LETTER OF TRANSMITTAL

SUBJ: Drainage Plan for Blanchat Machine Addition

DRAINAGE PLAN FOR BLANCHAT MACHINE COMPANY ADDITION **N.W.1/4, S. 25, T.27S., R.1W. OF THE 6TH P.M.** **WICHITA, SEDGWICK COUNTY, KS**

DRAINAGE PLAN FOR BLANCHAT MACHINE COMPANY ADDITION 3323 MAPLE, WICHITA, KS		
PROJ. NO.: CERTIFIED ENGINEERING DESIGN		
438 NORTH OHIO WICHITA, KANSAS 67214 (316) 262-8808		
DESIGNED: HDF	SCALE: 1" = 40'	SHEET 1
DRAWN: TILS, HDF	DATE: 6-1-98	
CHECKED: HDF	CEI FILE: BLANCHAT.DWG	TOTAL 1

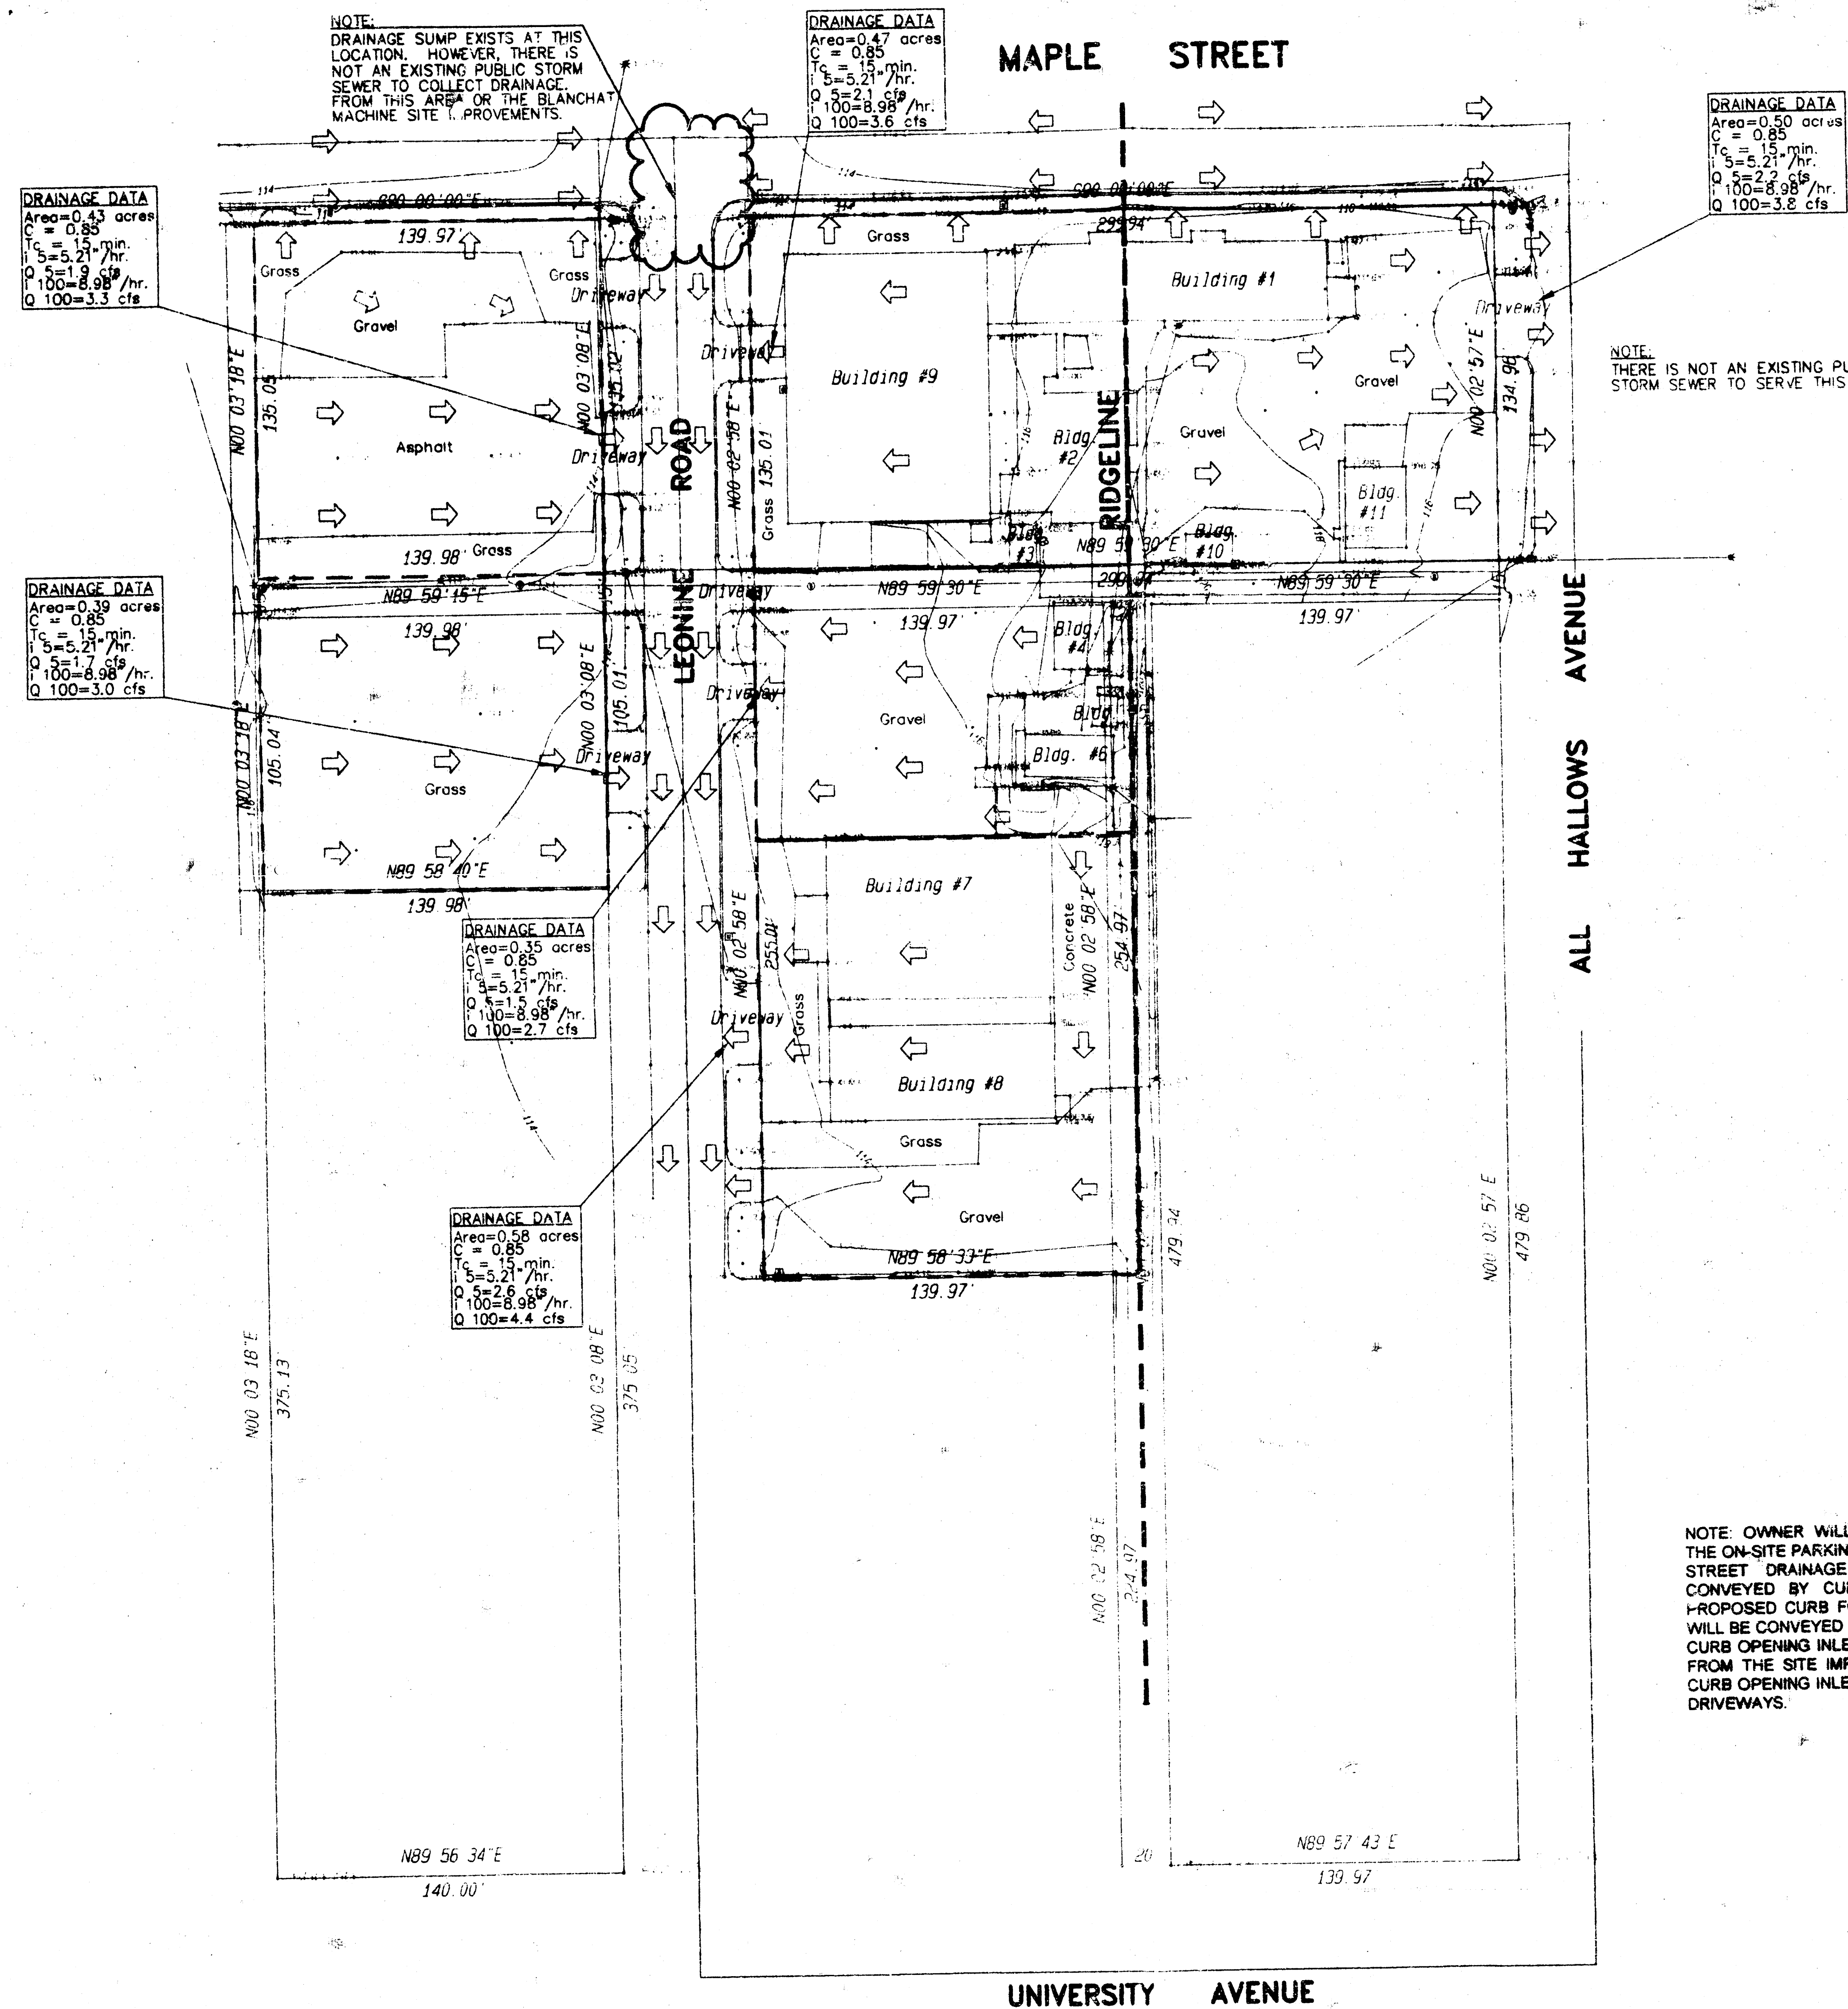
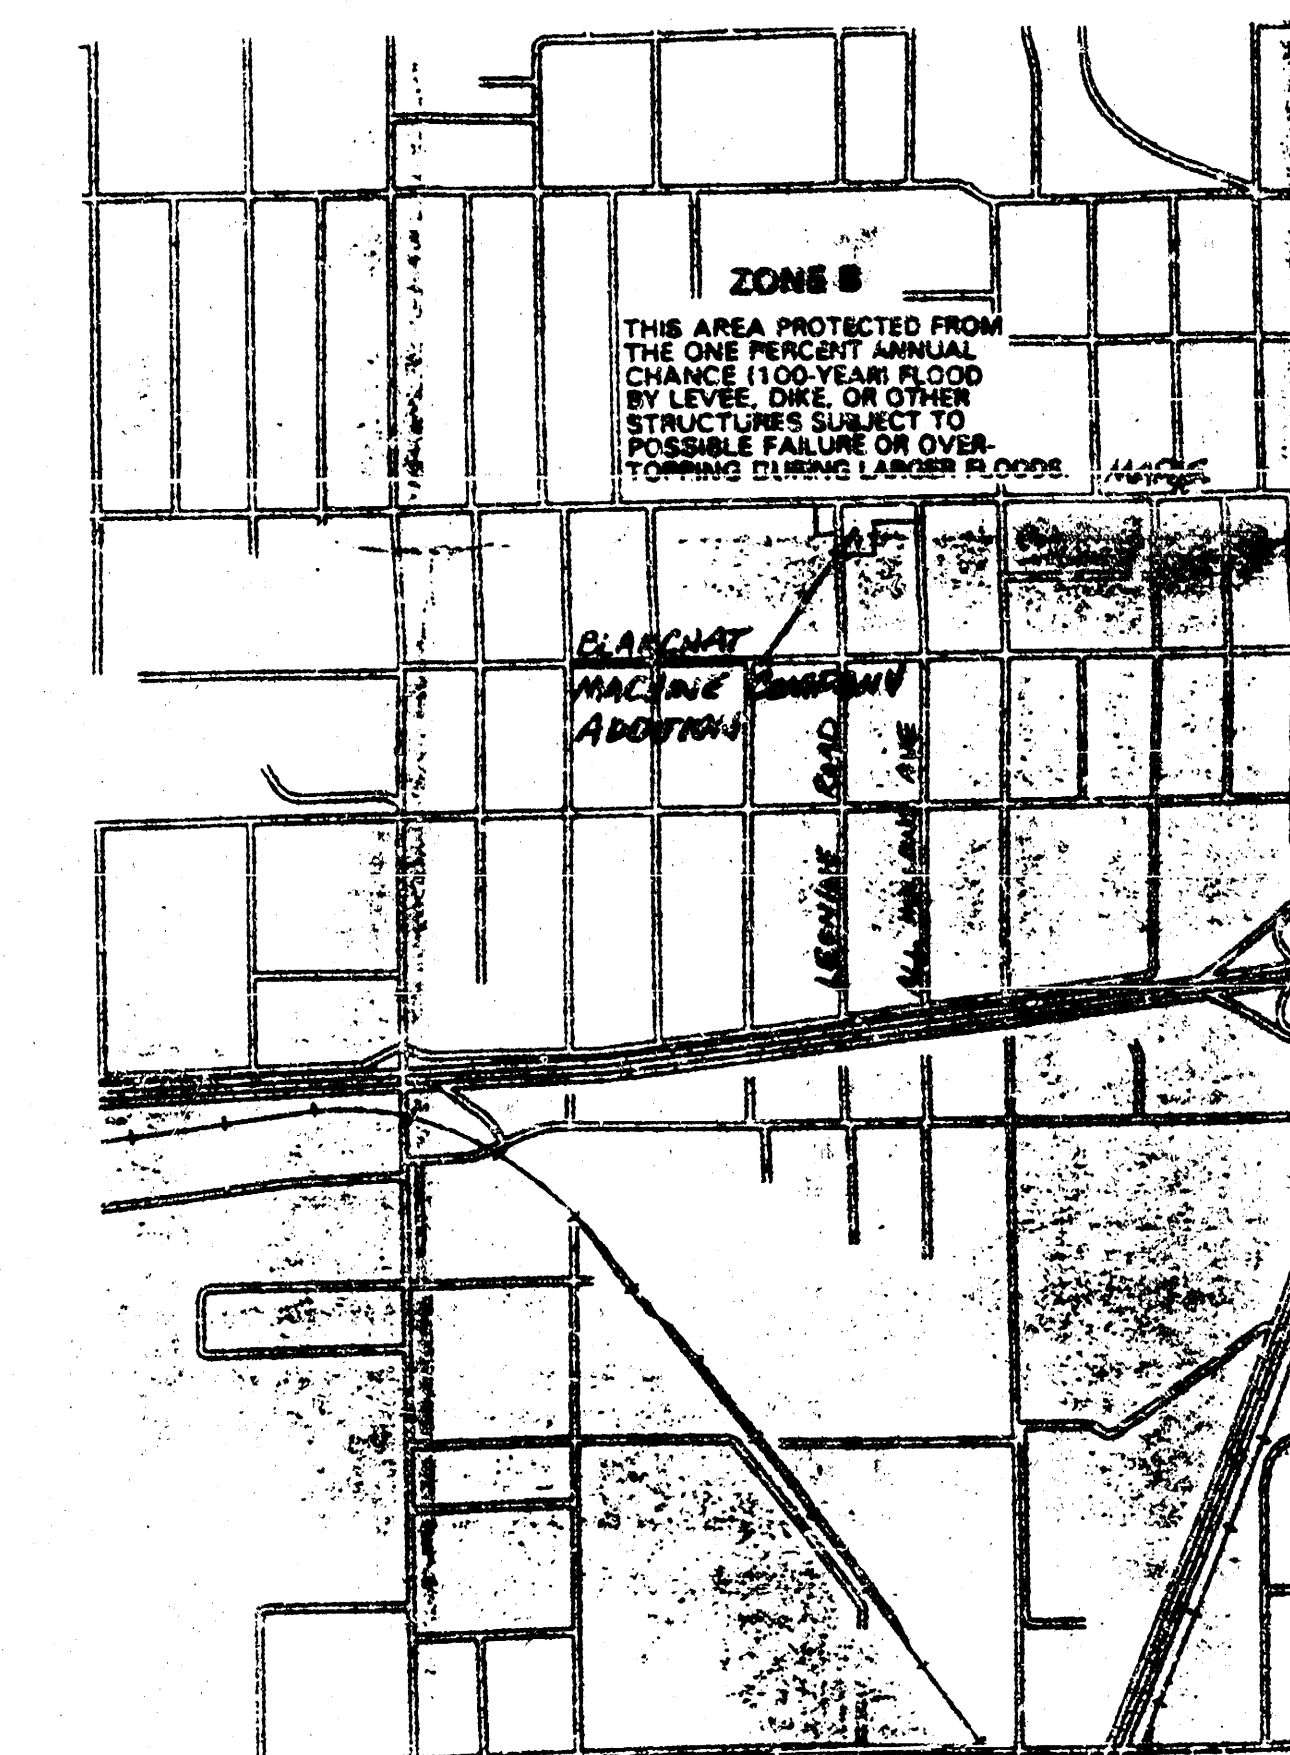
COMMENTS: Attached find the revised drainage plan for the above referenced addition. A note has been added to the drainage plan requiring on-site parking lot detention will be required when the site improvements are constructed.

NOTE: OWNER WILL IMPLEMENT DETENTION STORAGE INTO THE ON-SITE PARKING LOTS AND WILL RESTRICT FLOW TO THE STREET DRAINAGE SYSTEM TO THAT WHICH WILL BE CONVEYED BY CURB OPENING INLETS LOCATED IN THE PROPOSED CURB FOR THE ON-SITE PARKING LOT. RUNOFF WILL BE CONVEYED TO THE STREET CURB VIA 6" PVC PIPE AND CURB OPENING INLETS IN THE STREET CURB. THE DRAINAGE FROM THE SITE IMPROVEMENTS WILL BE DIRECTED TO THE CURB OPENING INLETS AND WILL NOT BE CONVEYED OUT THE DRIVEWAYS.
